Interactive comment on “Automatic high-frequency measurements of full soil greenhouse gas fluxes in a tropical forest” by Elodie Alice Courtois et al.

RC1, Referee #1 (Remarks to the Author):

Figure 1: Daily temperature variation at 2m height under the canopy cover during the study period (June-September 2016).

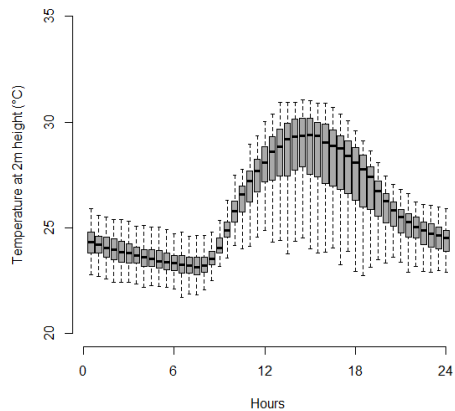
1. How did the authors keep moisture from affecting sampling, either within the tubing lines or when moving from IRGA to Picarro? Was there any moisture buildup in the tubing lines?

Response: We also worried about moisture problems prior to our experiment, but such problems never occurred. No significant condensation occurred in our system, we assume because temperature variations were typically small below the canopy, varying from 22°C in the night to 28°C during the day (see Figure attached). We regularly checked that no liquid water accumulation occurred in the sampling tubes. Moreover, both analysers measure water vapor and account for its effect on concentration of CO₂, CH₄ and N₂O .

Changes in the manuscript: Temperature variations are typically small below the canopy due to the shadowing by dense canopy crown and microclimatic conditions. During the study period, temperature at 2m height varies during the day from 22 °C in the night to 28 °C during the day. The presence of water condensation inside the tubing lines was carefully checked every week and never occurred during the study period.
